#### **Addendum 47 – Regulation No. 48**

#### **Revision 9 - Amendment 1**

Supplement 1 to the 06 series of amendments – Date of entry into force: 15 July 2013

**Uniform provisions concerning the approval of vehicles with regard to the installation of lighting and light-signalling devices**

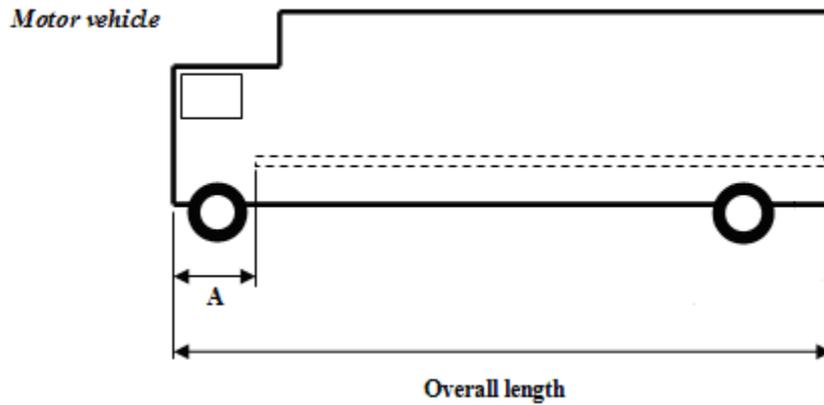
- 6.21.4.2.1. The conspicuity marking shall be as close as practicable to the ends of the vehicle and reach to within 600 mm of each end of the vehicle.

- 6.21.4.2.1.1. For motor vehicles, each end of the vehicle, or in the case of tractors for semi-trailers each end of the cab;

However, an alternative marking mode within 2,400 mm from the front end of the motor vehicle is allowed where a series of retro-reflectors of Class IVA of Regulation No. 3 or Class C of Regulation No. 104 are mounted followed by the required conspicuity marking as follows:

- (a) Retro-reflector size minimum 25 cm<sup>2</sup>;
- (b) One retro-reflector mounted not more than 600 mm from the front end of the vehicle;
- (c) Additional retro-reflectors spaced not more than 600 mm apart;
- (d) The distance between the last retro-reflector and the start of the conspicuity marking shall not exceed 600 mm;

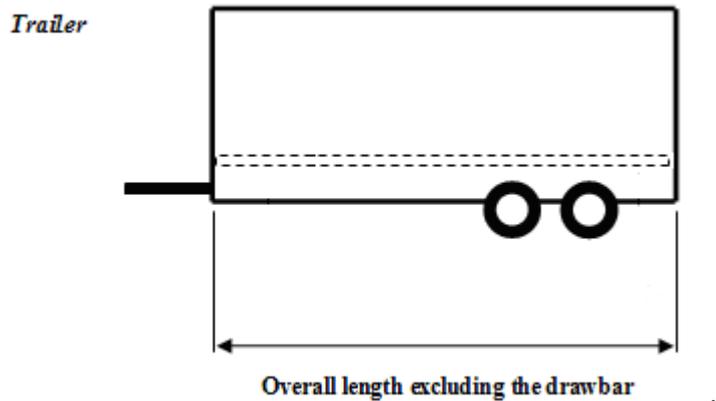
- 6.21.4.2.2.1. For motor vehicles, length of vehicle, or in the case of tractors for semi-trailers, if fitted, the length of the cab; however, when using the alternative marking mode per paragraph 6.21.4.2.1.1., the distance beginning within 2,400 mm from the front end of vehicle to its rear end.

A is the distance between the foremost conspicuity marking and the front end of the vehicle. The maximum value of A is 2,400 mm (see paragraph 6.21.4.2.1.1.)."
